Technical Service Information

NISSAN E/L4N71B OVERDRIVE SECTION FAILURE

Figure 1

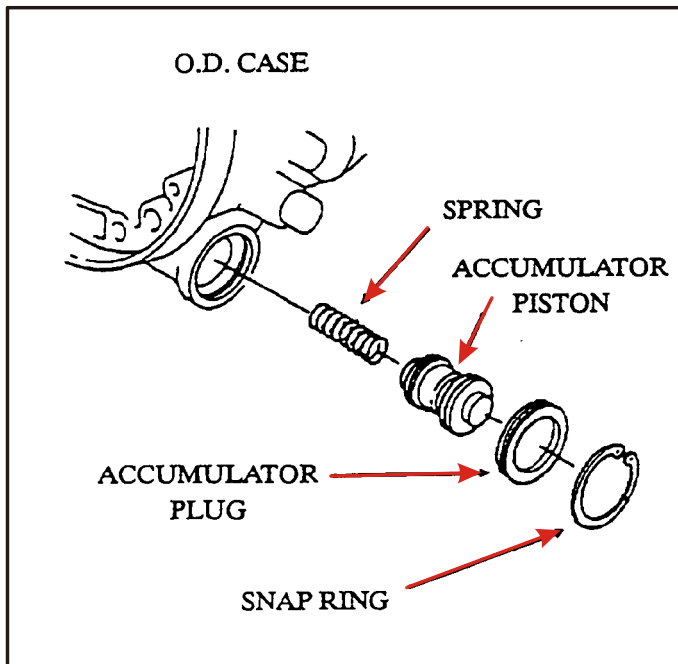
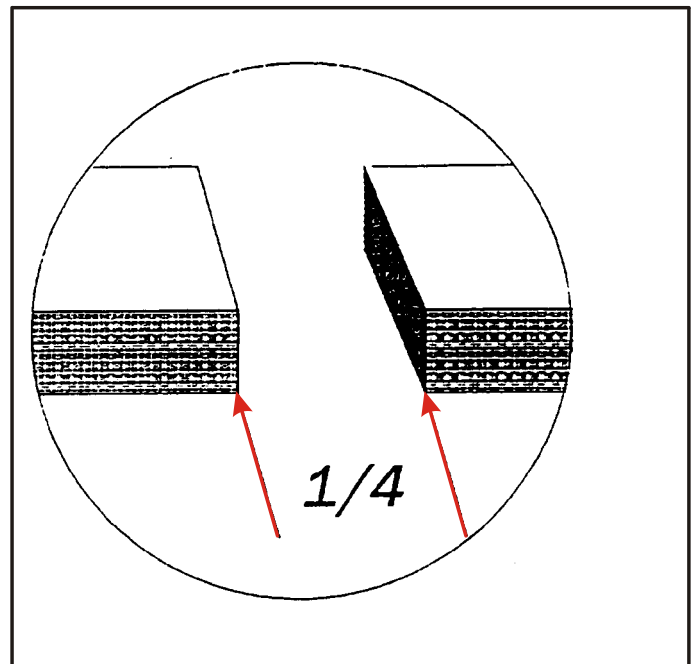
COMPLAINT: Overdrive section wiped out - overheating evident after rebuild.

CAUSE: The overdrive accumulator ring is cutting off lube flow to the O.D. case (Figure 1).

CORRECTION: The O.D. accumulator ring should have a 1/4" gap when fitted in the accumulator bore. This 1/4" gap allows lube oil to flow into the O.D. case (Figure 2).
